Access Compliance Report

Public Rights-of-Way

Intersection ID: 45513	Main Street: FIRST_BLOOM_RD	Cross Street: HEDGEROW_PARK_RD	Location: NW
ADA ID: 839E47896150	Ramp Type: Combination1Diag	Initial Pass/Fail: Fail	Overall Compliance: No
		Severity Score: 0

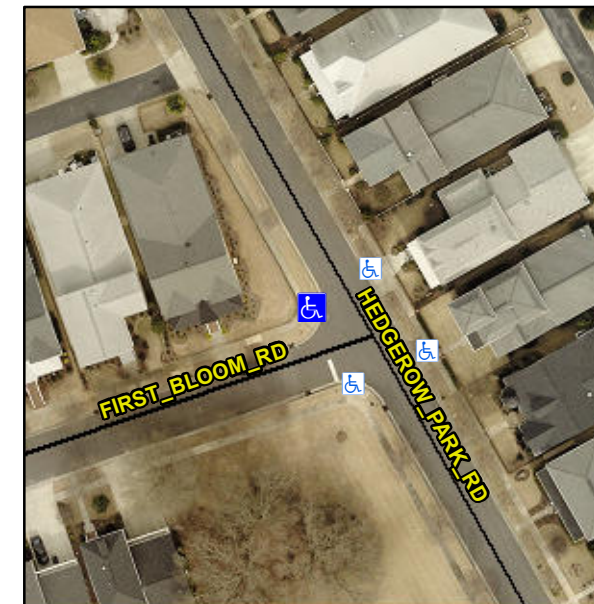
LT RP < 5%

Not Found, R304.5.1, R304.5.1, R304.5.3

Remove & Replace Curb Ramp With Two New Directional Ramps or Equivalent.
